TECHNICAL SERVICE BULLETIN

Classification: FE23-001	Reference: NTB23-055	Date: June 21, 2023
-----------------------------	-------------------------	------------------------

FUEL ODOR

APPLIED VEHICLES: 2021-2023 Rogue (T33)
APPLIED ENGINES: KR15DDT

Figure 2

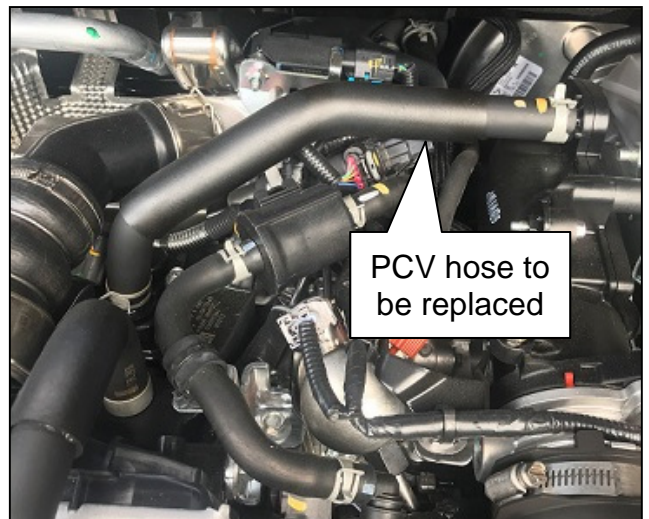
- b. Locate the PCV hose to be replaced.

Figure 3

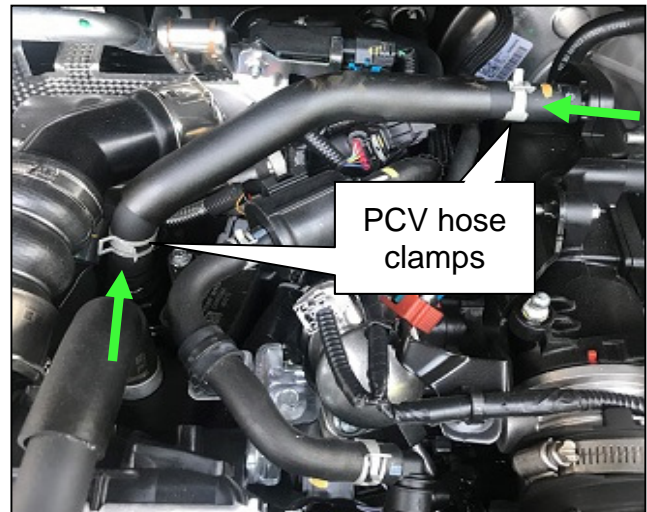
- c. Relocate the clamps that secure the PCV hose, to allow for PCV hose removal.

Figure 4

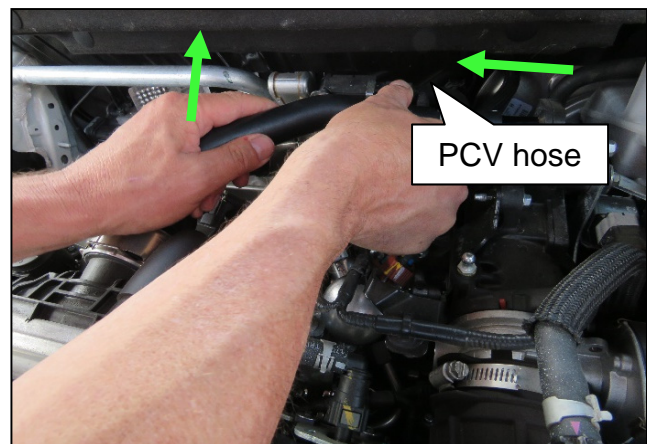
- d. Pull on the PCV hose in the directions shown in Figure 4, for PCV hose removal.

- e. Install the new PCV hose in the reverse order of removal.
- f. Reinstall the engine cover.
